AMENDMENT OF SOLICITATION/MODIFICATION OF CONTRACT		1. CONTRACT ID CODE	PAGE OF PAGES 1 1
2. AMENDMENT/MODIFICATION NO. 000002	3. EFFECTIVE DATE 05/03/2017	4. REQUISITION/PURCHASE REQ.NO.	5. PROJECT NO. (If applicable)
6. ISSUED BY FEDERAL AVIATION ADMINISTRATION WESTERN SERVICE AREA 1601 LIND AVE SW AAQ-530-ANM ACQUISITION GROUP RENTON WA 98057	CODE AAQ530ANM-AFN	7. ADMINISTERED BY (If other than Item 6)	CODE
8. NAME AND ADDRESS OF CONTRACTOR (No., street, county, State and ZIP Code)		(x) 9A. AMENDMENT OF SOLICITATION NO. DTFASA-17-R-00370	
CODE		FACILITY CODE	X 9B. DATED (SEE ITEM 11) 03/21/2017
		10A. MODIFICATION OF CONTRACT/ORDER NO.	
		10B. DATED (SEE ITEM 13)

SEE ATTACHED LIST OF QUESTIONS RECEIVED AND APPLICABLE ANSWERS.

ZOA ARTCC RESTROOM RFI's

**Figure 604.8.1.1
Size of Wheelchair Accessible Toilet Compartment**

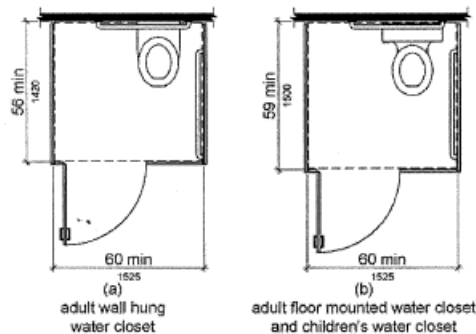
7. Not sure if because federal but the stall layouts do not meet CA ADA legal. ADA stall is not deep enough to swing door in. You would need 56" + 34" + thickness of material to swing the door in with a wall-mounted toilet, and 3" more than that if floor mounted toilet – for stall depth. You could swing the door out normally, but you wouldn't have the clearances needed for that either. Room is too small and trying to get too many fixtures in there. Architect should be able to lay it out with some changes...

Response: Because this is a federal facility, we are bound by the American Barriers Act and the ADA, as specified in the contract. The American Barriers Act states that the design complies with the project design. Detailed in the following figures:
